Marinus Link Pty Ltd
PO Box 606 Moonah
Tasmania 7009

Application No: DA 2022/76
Council reference: SP: CF 2920337 & 9296310
Land: Corner of Minna Road and Bass Highway, Heybridge and 22 Minna Road, Heybridge
Proposal: Heybridge Converter Station, Marinus Link

Response to RFI dated 28 July 2022

Response to RFI dated 24 August 2022

Figure 17
Landslip hazard overlay

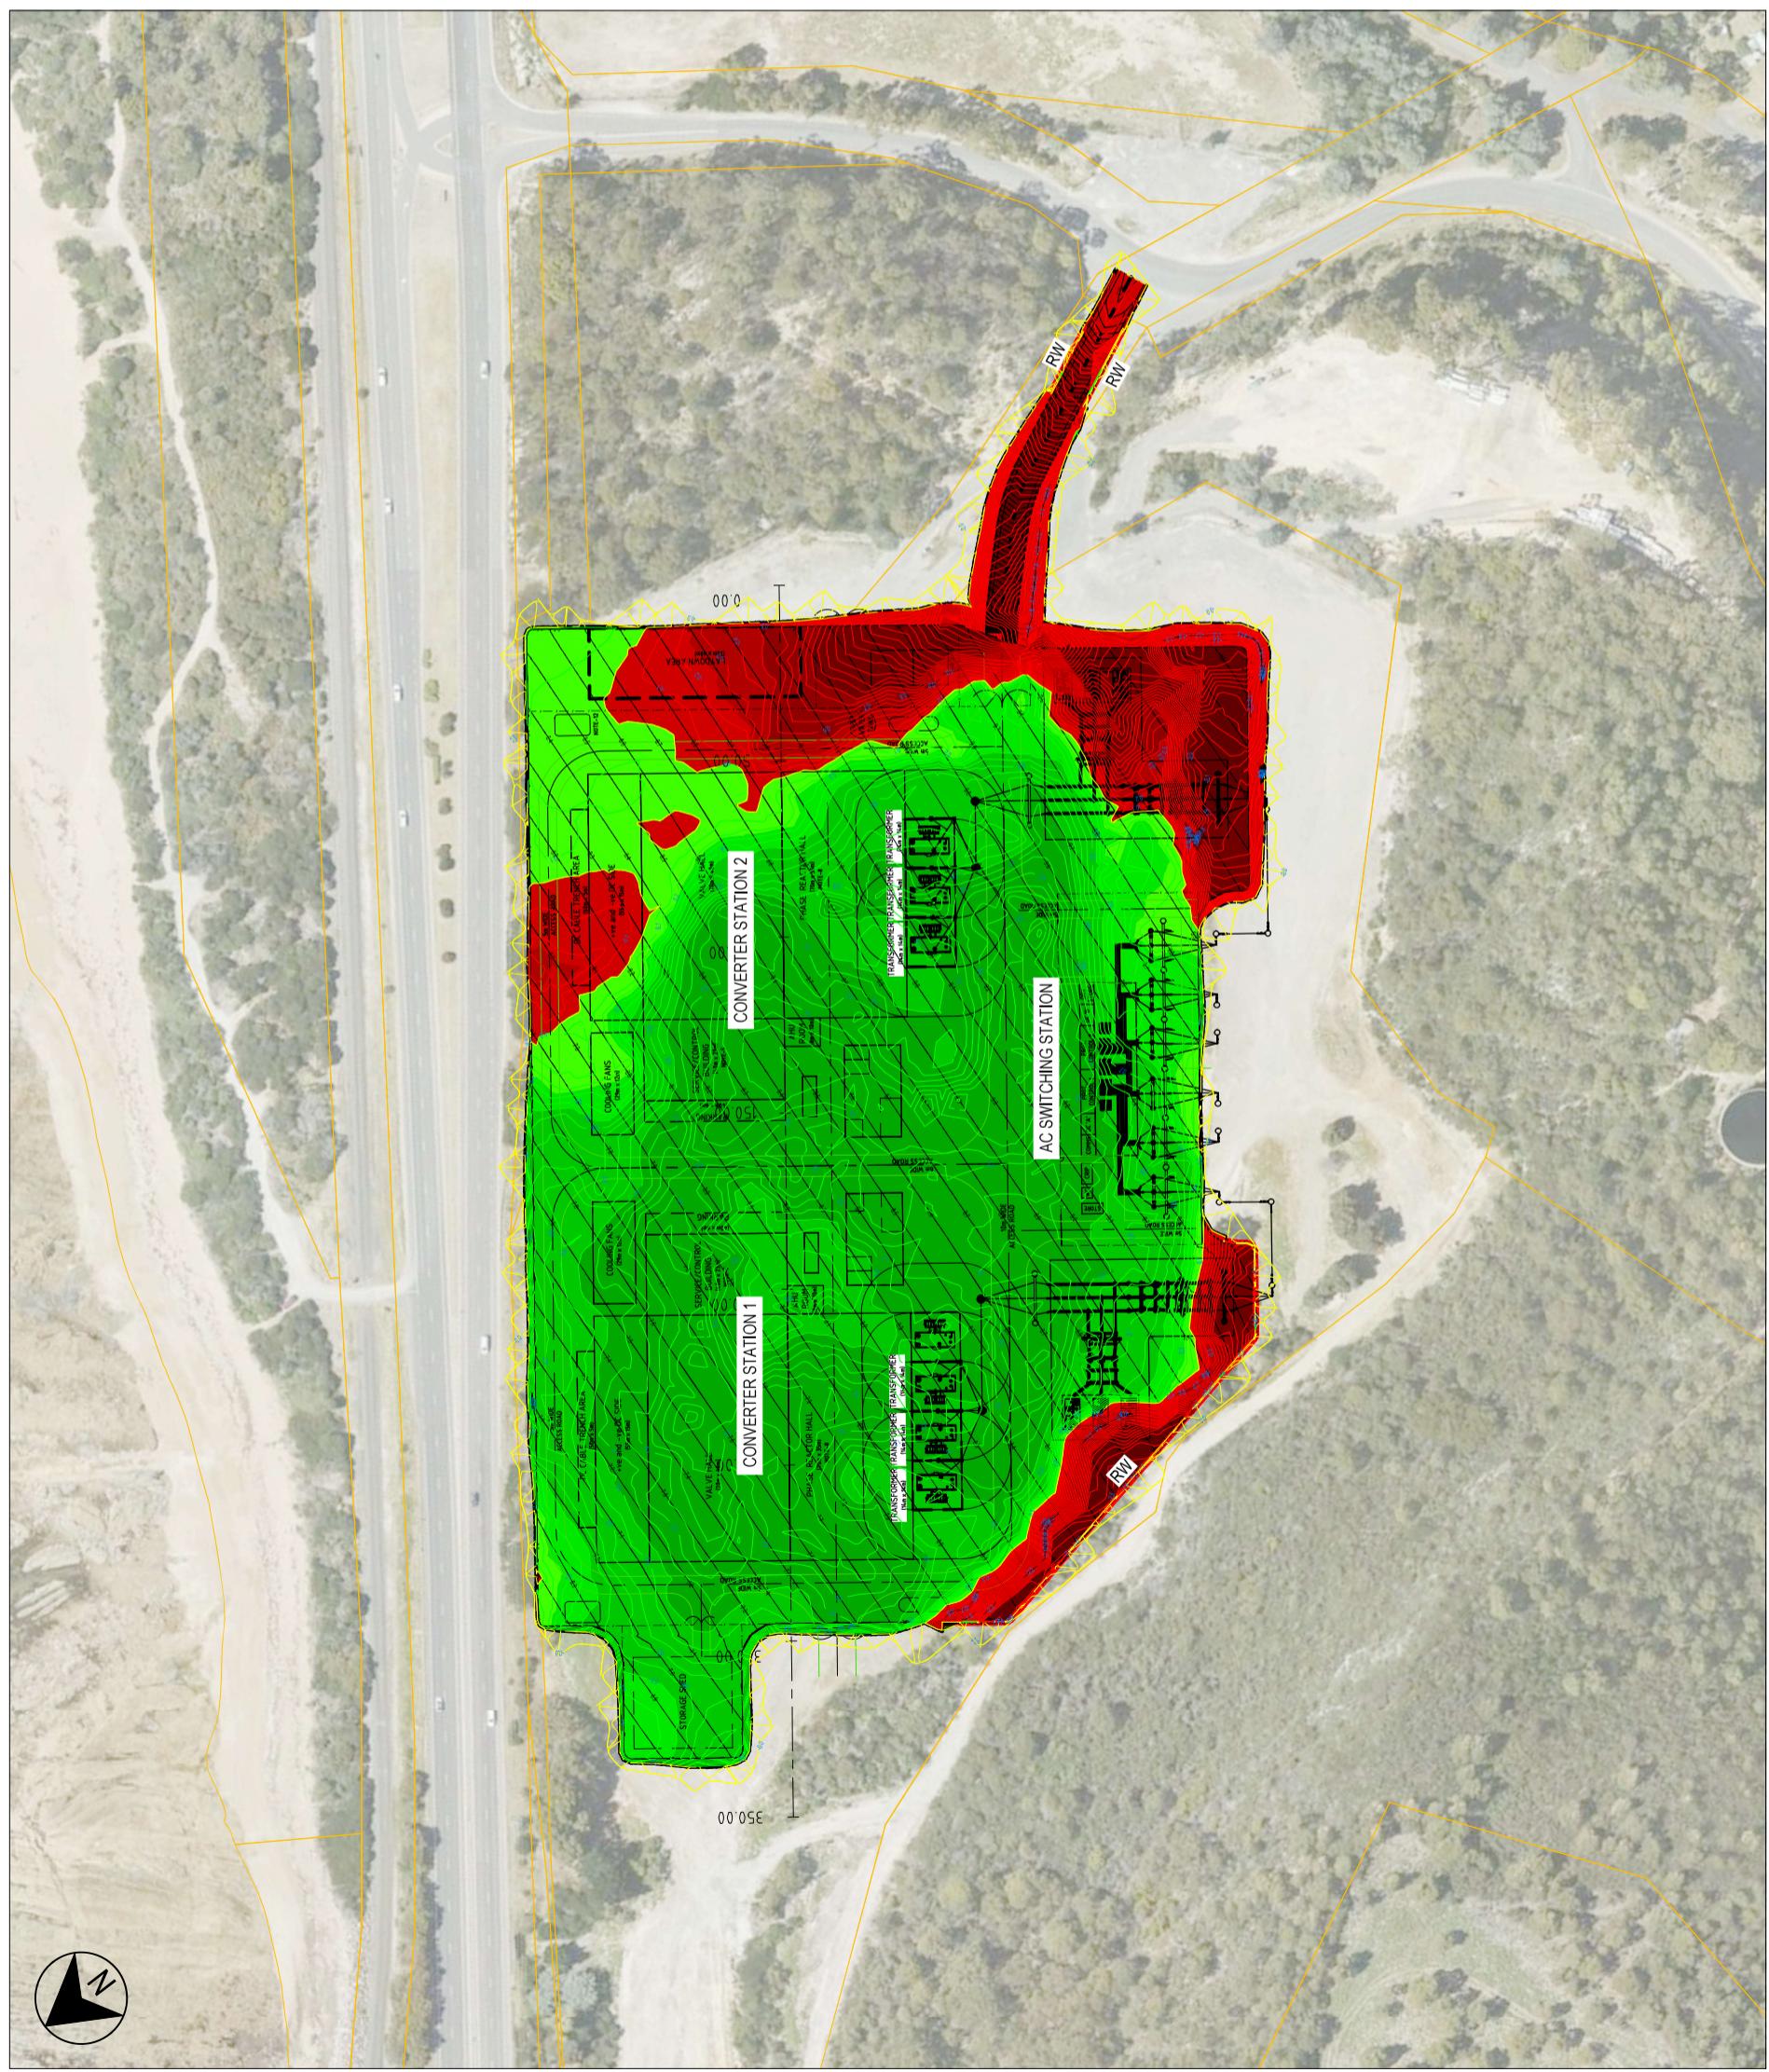
Additional information is required to clarify if there are any significant works (as defined within the Code) proposed through cut or fill in the areas on the site identified as low or medium landslide hazard. If so, demonstration against clause C15.6.1 P1.1 and P1.2 is required.

A preliminary conceptual design of the cut and fill requirement for the proposal site during construction shows that excavation of the south-western and eastern boundaries of the site would be required to level and fill the lower elevations in the centre and north of the site. An average excavation down to 1m across the footprint of the converter station is expected. Further assessment during the design phase will confirm the depths proposed.

Under C15.6.1, building and works within a mapped landslip hazard area should minimise the likelihood of triggering a landslip event and maintain a tolerable risk. The south-west portion of the site determined for cut would intersect an area mapped as low landslip hazard.

As such, performance criteria P1.1 and P.2 would apply and the proposal would align with the criteria as part of further detailed design, as specified in Table 12-1.
